PRCOM20224906

REVISDE 6/22/2023

I-470 BUSINESS & TECHNOLOGY CENTER, LOT 7

ISSUED FOR PERMIT OWNER REVISIONS

SITE ESC PHASE 1 AND 2 PLAN

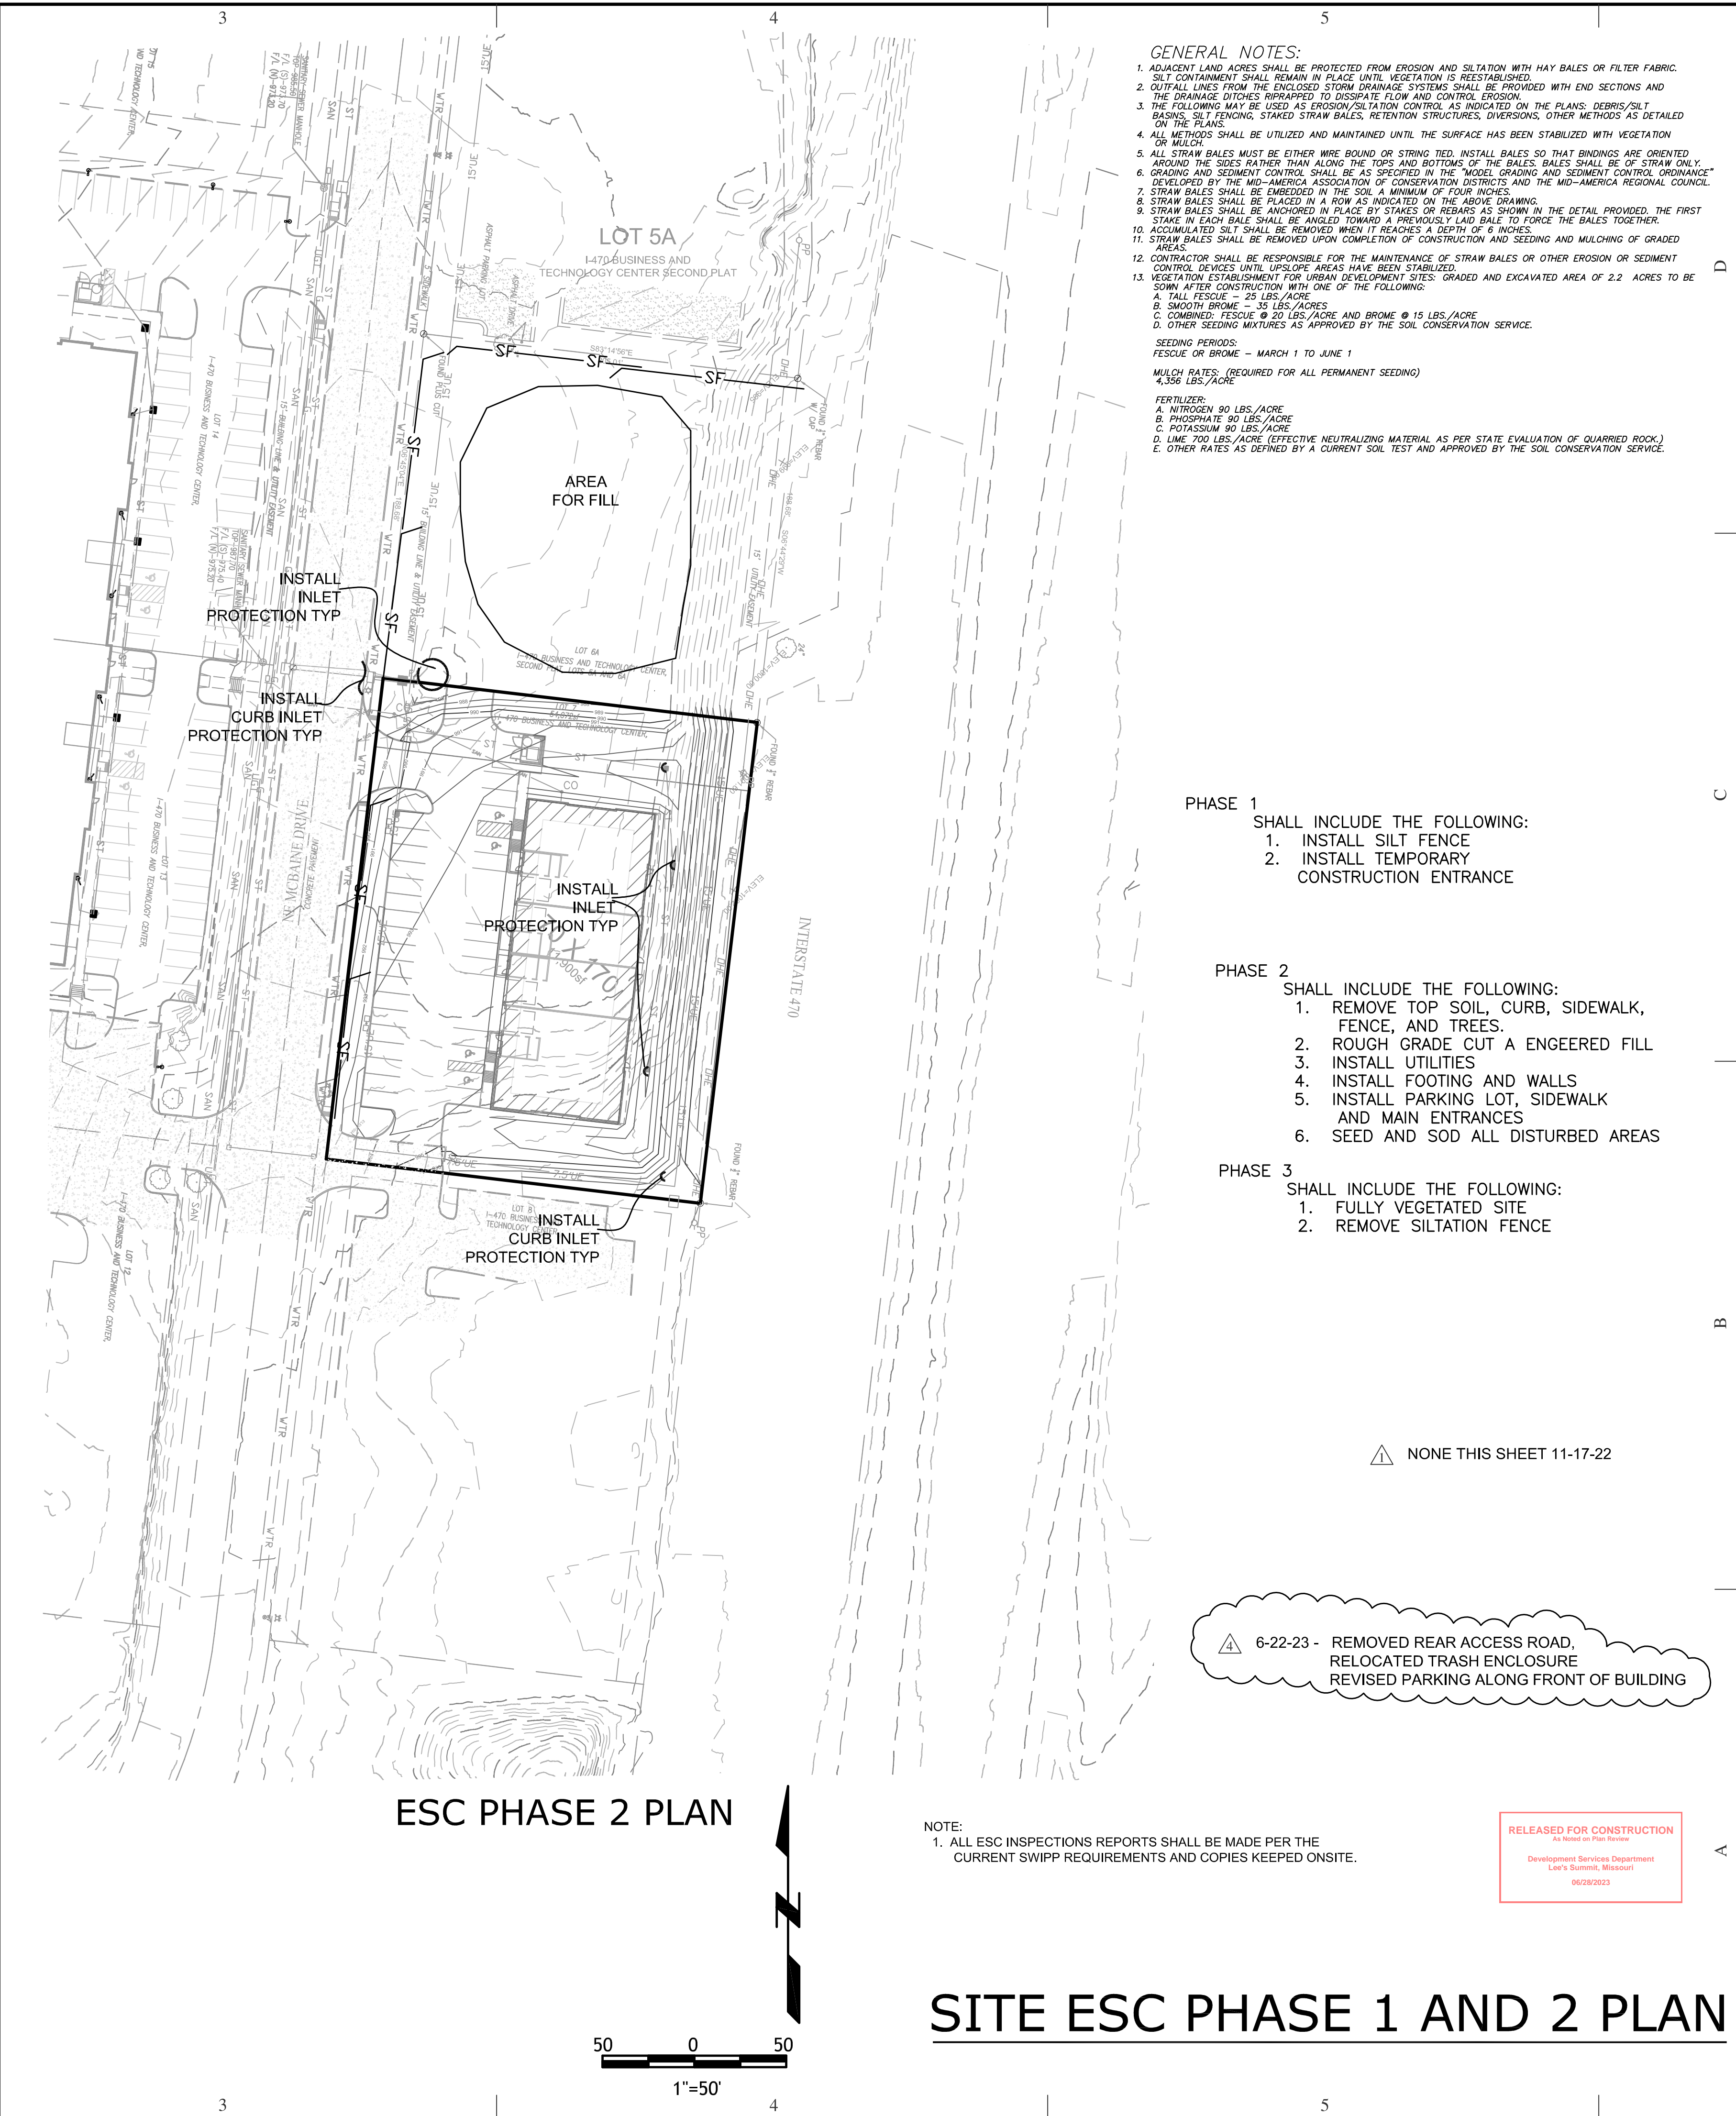
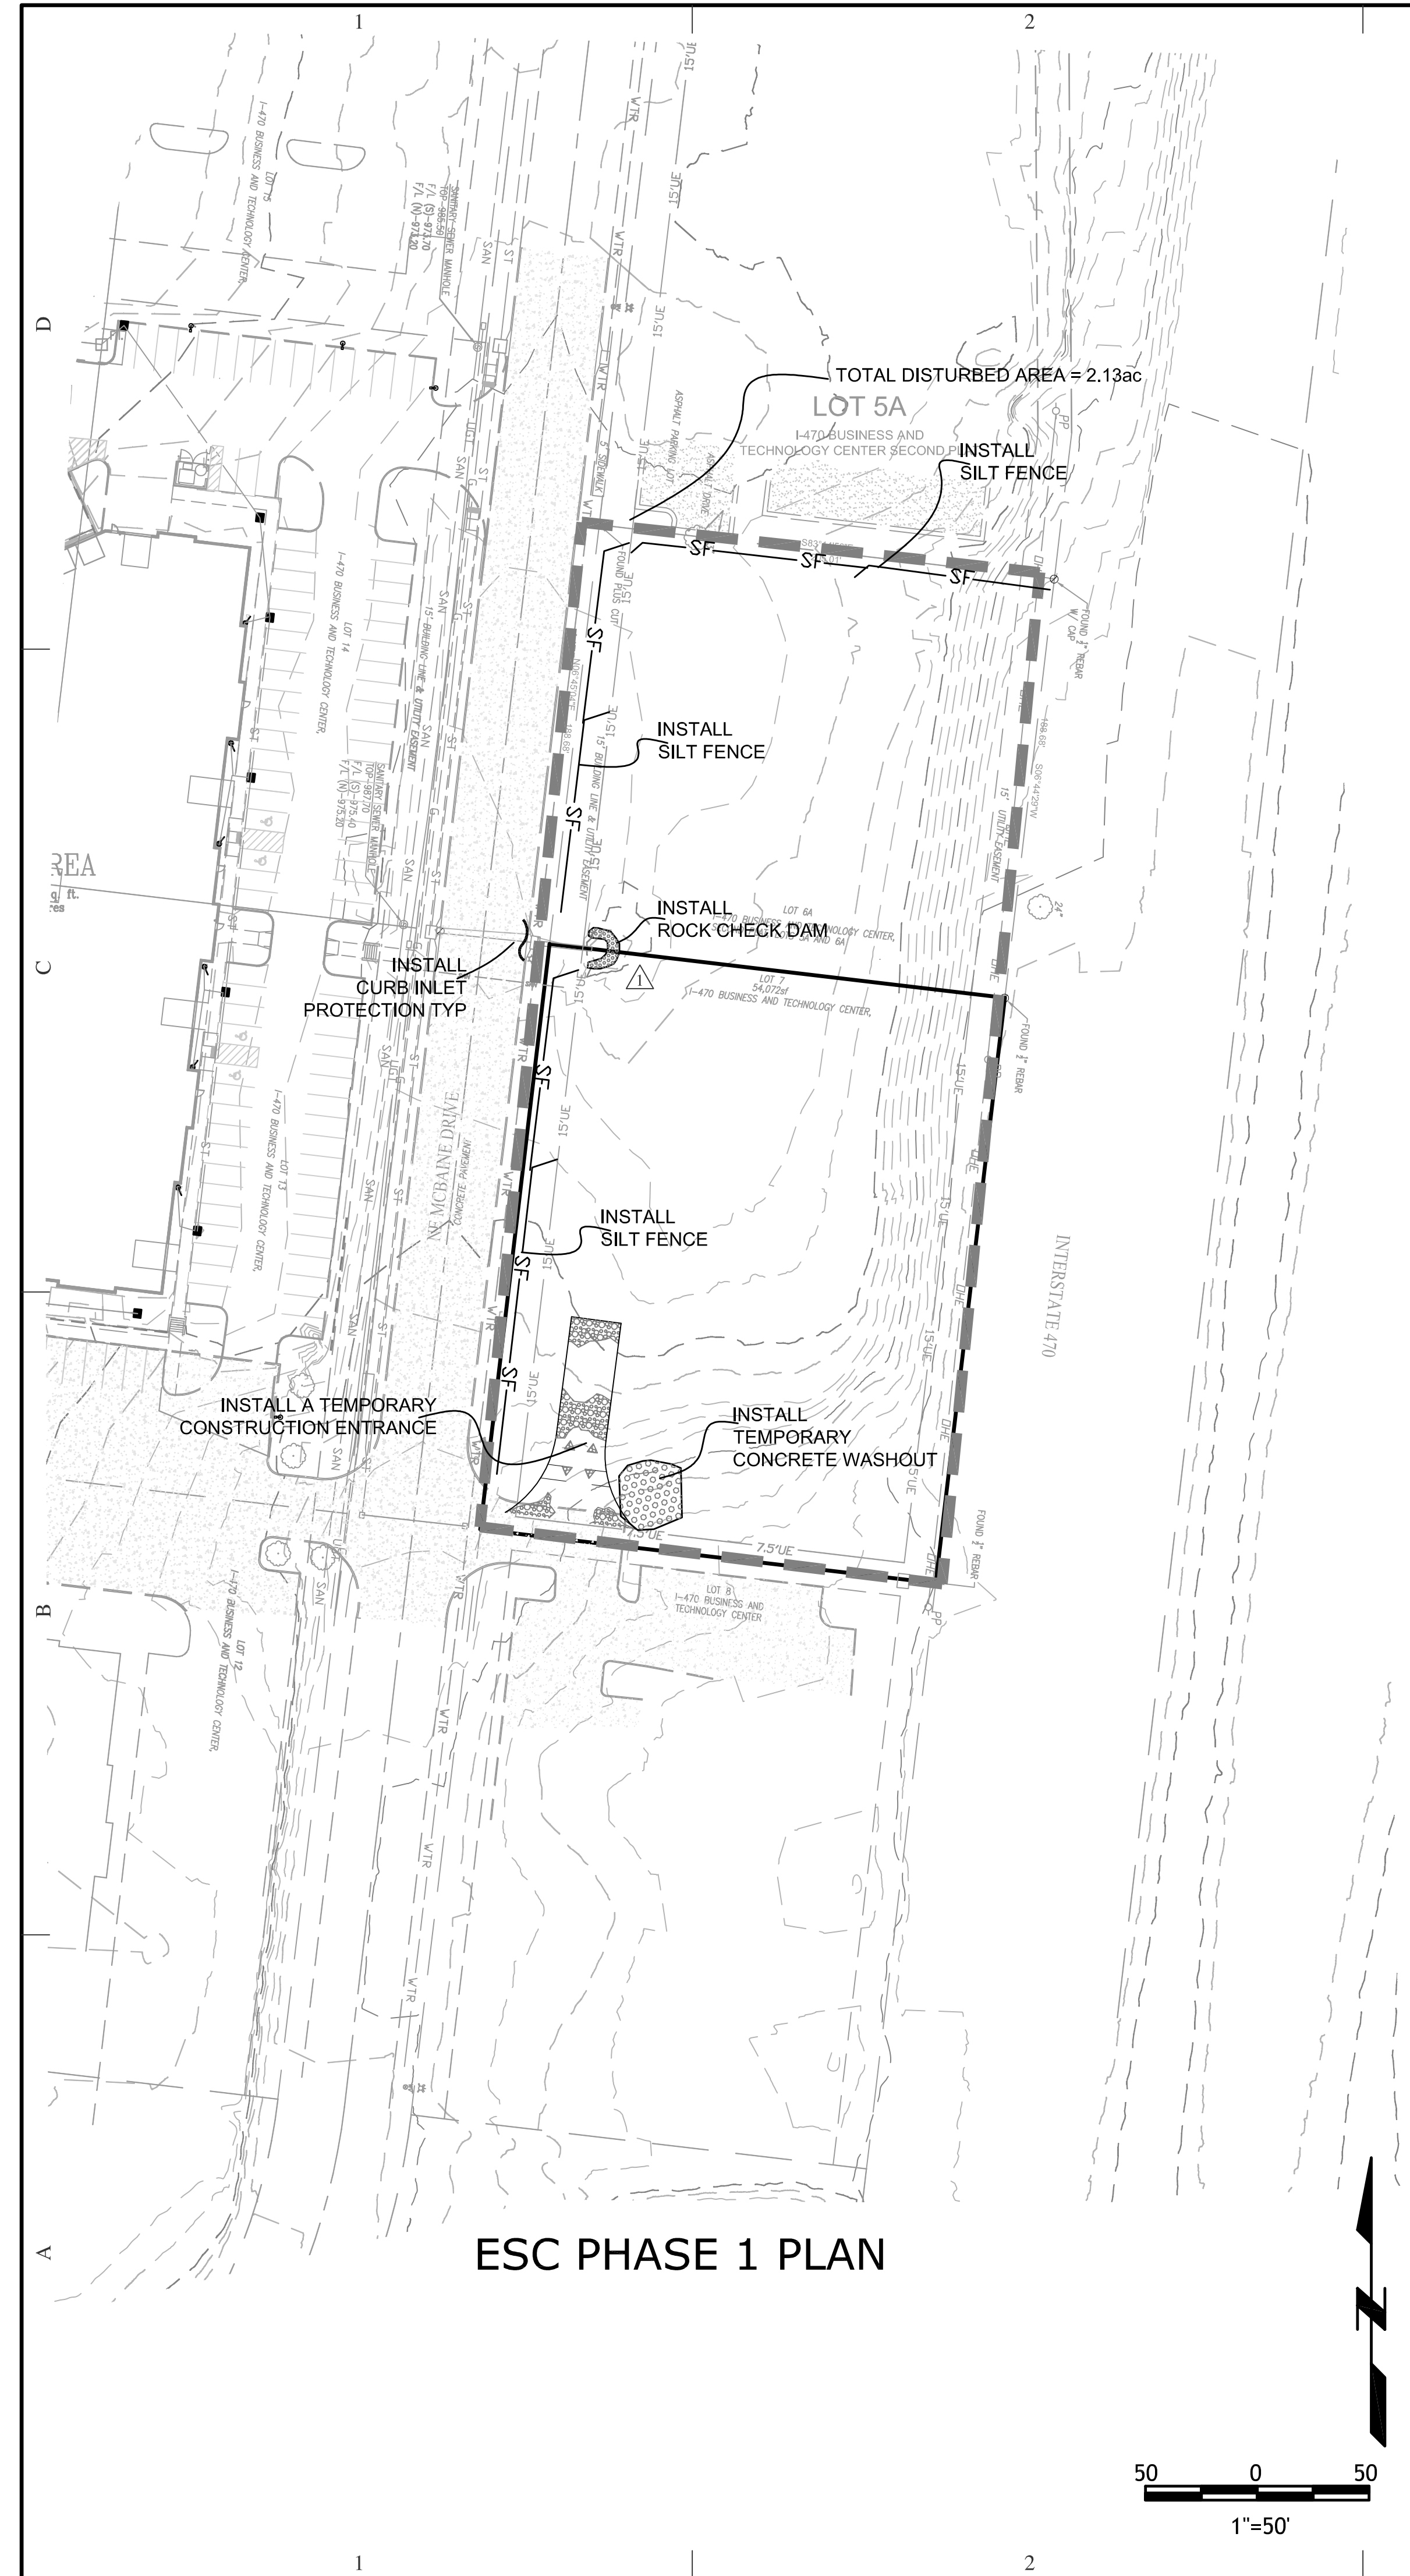
△ 6-22-23 - REMOVED REAR ACCESS ROAD, RELOCATED TRASH ENCLOSURE, REVISED PARKING ALONG FRONT OF BUILDING
